Project: IEEE P802.15 Working Group for Wireless Personal Area Networks (WPANs)

Submission Title: Enhancements to the Physical Layer of IEEE 802.15.3d Follow-up: Questions and Suggestions for Implementation Date Submitted: 25 April 2022 Source: Duschia Bodet & Josep Miquel Jornet at Northeastern University Address: 360 Huntington Ave, Boston, MA 01845, USA Voice: +1 617 373 4548, E-Mail: bodet.d@northeastern.edu

Re: Enhancements to the Physical Layer of IEEE 802.15.3d for Increased Data Rate and Coexistence/0125-01

IEEE P802.15.3ma Proposal Follow-up: Questions and Suggestions for Implementation

13.2.2.1 Modulation

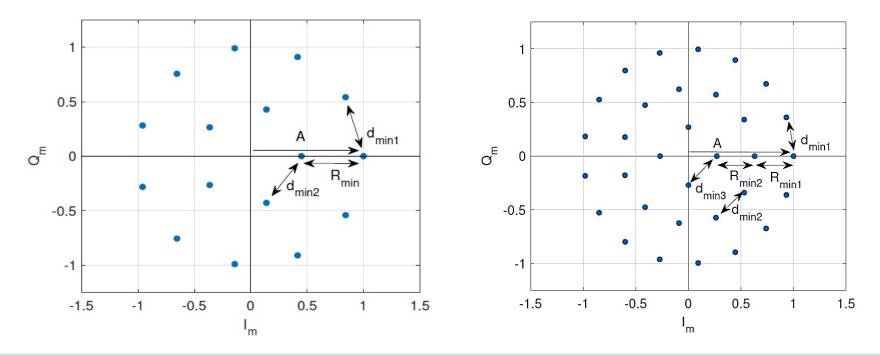
Questions for the Group:

Why do you specify 3 bits per symbol? What do you mean by the input bit d1? Also are the parenthesis around sqrt(10) intentional?

Proposed Edit

The constellation diagrams of $\pi/2$ 8-APSK, 16-APSK, and 32-APSK are shown in Figure 13-3, Figure 13-4, and 13-5 respectively.

The normalization factors for $\pi/2$ QPSK, $\pi/2$ 8-PSK, $\pi/2$ 8-APSK, 16-APSK, 32-APSK, 16-QAM 64-QAM are 1, 1, $\sqrt{2}/\sqrt{11}$, _____, 1/ $\sqrt{10}$, and 1/ $\sqrt{42}$ respectively.
